Memo

Development Assessment

Subject: DA2024/0492 – 49 Blackbutts Road, Frenchs Forest and 21A Warili Road Frenchs Forest.

Condition 9

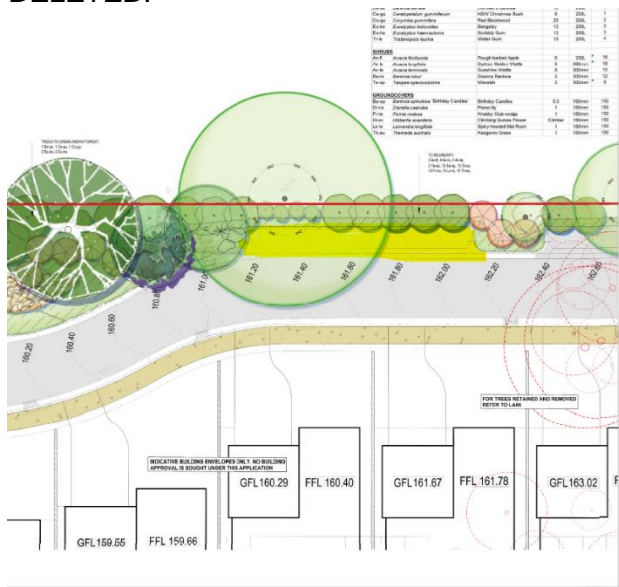
The plans addressed the following points raised under Condition 9 “Amendments to Approved Plans:

- *the retaining walling along the along the eastern boundaries of lots 5 to 13 inclusive shall be relocated to provide an unobstructed landscape planting zone (a **minimum of 2m wide**). The stormwater pits and drainage lines shall be relocated accordingly.*
- *The three on-street car parking spaces to the south (highlighted in yellow below) are to be deleted and replaced with landscaping with proposed planting extended.*

As such, it is recommended that these points are deleted under condition 9. An updated Landscape Plan was not provided with the additional information, so there is no change recommended to the points relating to landscaping under condition 9.

9. Amendments to the approved plans

The following amendments are to be made to the approved plans:

- i) *DELETED*
- ii) *Along the entire southern boundary of lot 13, species obtaining a mature height of 2m are to be provided.*
- iii) *Along the eastern boundary (lots 5-13), species obtaining a mature height of 3m are to be provided.*
- iv) *DELETED.*
